# RENESAS TECHNICAL UPDATE

Product Category	MPU/MCU		Document No.	TN-RX*-A132A/E	Rev.	1.00
Title	Expansion of Specification for Block Erasure of Flash Memory, Disclosure of Specification for FRDYI Interrupt, Addition of Description for Memory Planes, and Correction of Electrical Characteristics for RX100 Series		Information Category	Technical Notification		
Applicable Product	RX110 Group RX111 Group RX113 Group	Lot No.	Reference Document	RX110 Group User's Manual: Hardware Rev.1.10 (R01UH0421EJ0110) RX111 Group User's Manual: Hardware Rev.1.20 (R01UH0365EJ0120) RX113 Group User's Manual: Hardware Rev.1.02 (R01UH0448EJ0102)		
		All

This document describes the expansion of the specification for block erase, disclosure of the specification for the FRDYI interrupt, and addition of description for memory planes regarding the above applicable products of RX100 series. It also describes the correction of "E2 DataFlash Characteristics" in the Electrical Characteristics section.

Figure 41.1 ROM Area and Memory Plane/Block Configuration

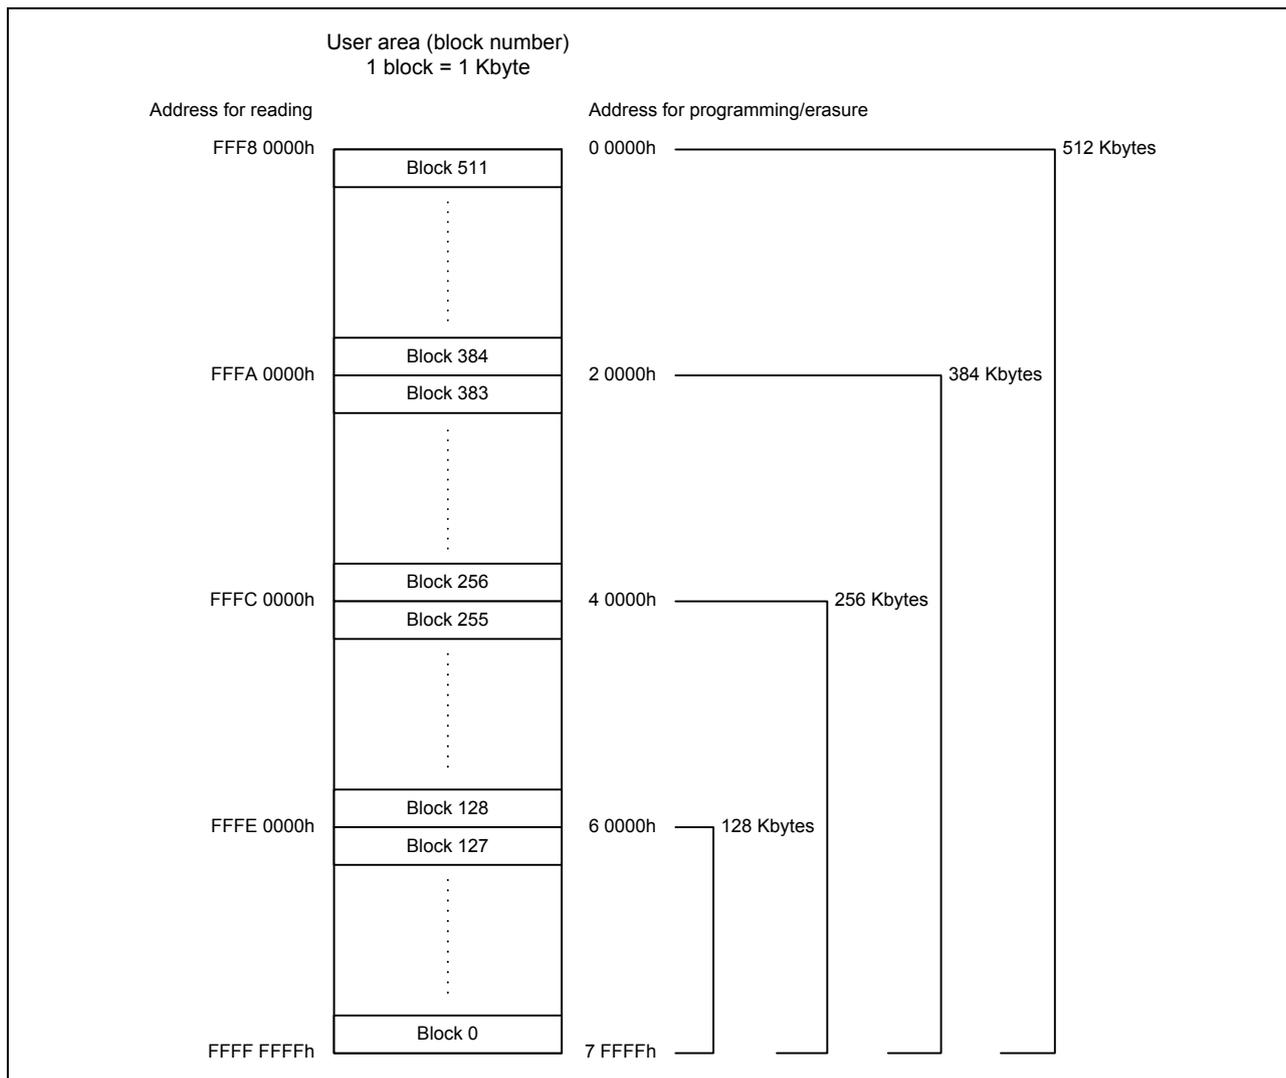
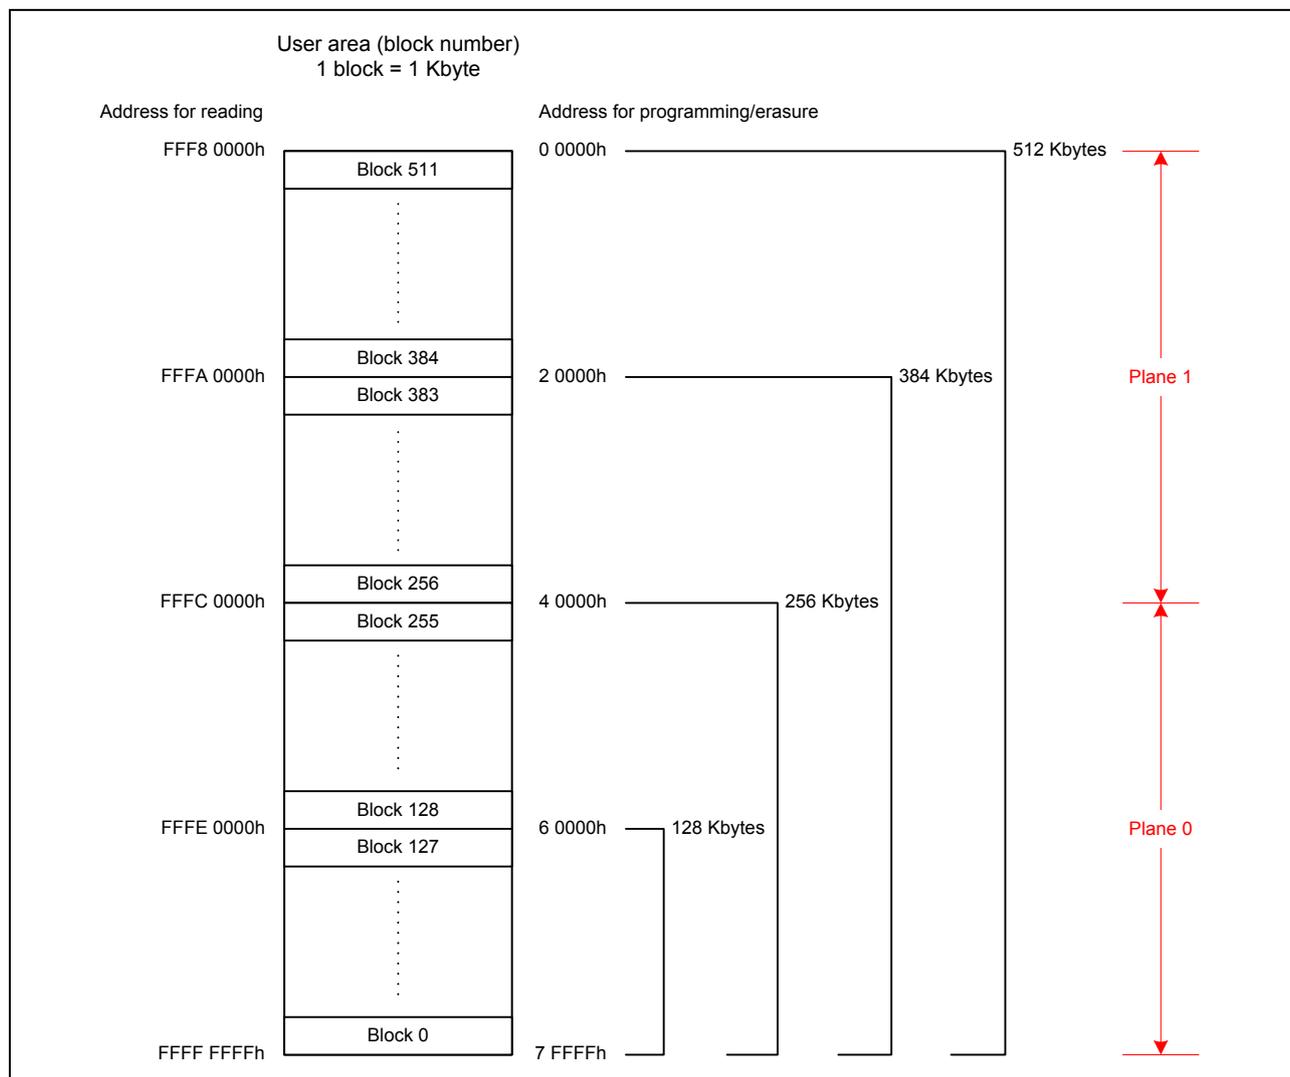
The description in section 41.2 ROM Area and Block Configuration and Figure 41.1 will be changed as follows.

A maximum of 512 Kbytes can be configured in the ROM area. The ROM area is divided into blocks according to the ROM capacity. The ROM area is erased in block units. Figure 41.1 shows the ROM Area and Block Configuration.

The maximum ROM size of this MCU is 512 Kbytes. Note that when the ROM size exceeds 256 Kbytes, the ROM area is divided into two memory planes on a 256-Kbyte boundary. Each plane is divided into 1-Kbyte areas (blocks), and one plane can have up to 256 blocks. When executing the block erase command, the memory is erased in block units. Figure 41.1 shows the ROM Area and Memory Plane/Block Configuration.
